UNITED STATES
NUCLEAR REGULATORY COMMISSION

ADVISORY COMMITTEE ON NUCLEAR WASTE
WASHINGTON, D.C. 20555-0001

SUBJECT: COMMENTS ON THE IMPORTANCE OF CHEMISTRY IN THE NEAR FIELD
TO DOE's YUCCA MOUNTAIN REPOSITORY LICENSE APPLICATION

CHEMISTRY IN THE PROPOSED YUCCA MOUNTAIN REPOSITORY NEAR FIELD

Figure 1. Waste Package and Drift Design Cross Section

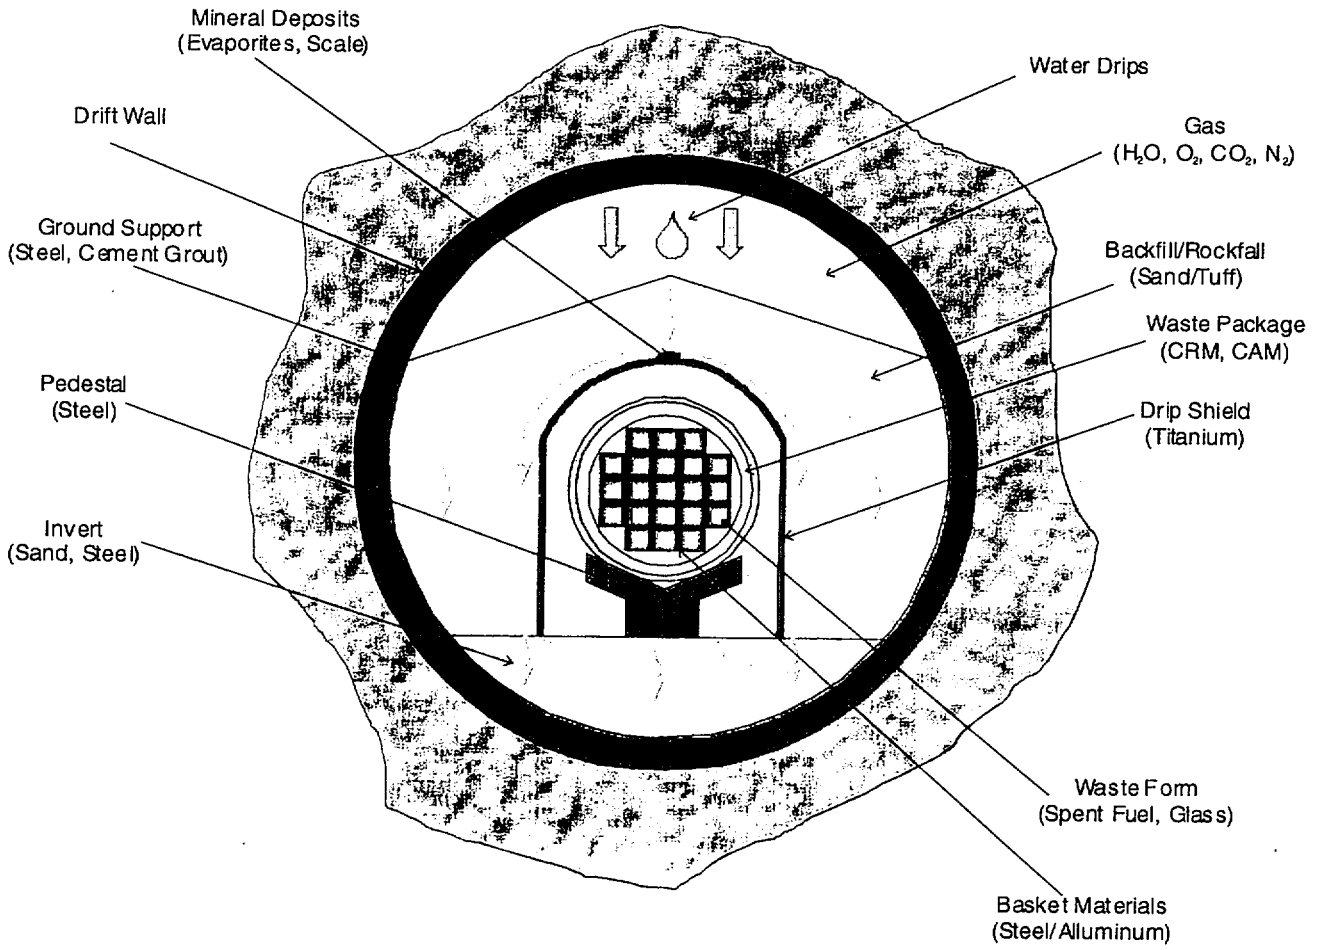
The current waste package design is shown in cross section Figure 1. The outer container has a 2 centimeter-thick wall of alloy C-22, whose composition is given in table 3. The inner container has a 5 centimeter-thick wall of stainless steel. It is expected that the stainless steel will corrode much faster than the C-22 once water breaches the C-22, and that in times far shorter than the repository licensing period it will be completely oxidized provided that the C-22 is in fact breached. As noted above, this steel could produce locally reducing conditions in the waste package or drift, and if oxidized, will add to the ionic iron content of the water. (Iron corrosion products would occupy more volume than the stainless steel from which they come, leading to potential adverse mechanical and structural effects. However, these effects are not considered here.) Unlike the steel in the waste package support and the steel invert, the iron ions from the stainless steel in the waste package container will be available for chemical reactions with the waste form itself at the water-waste interface.
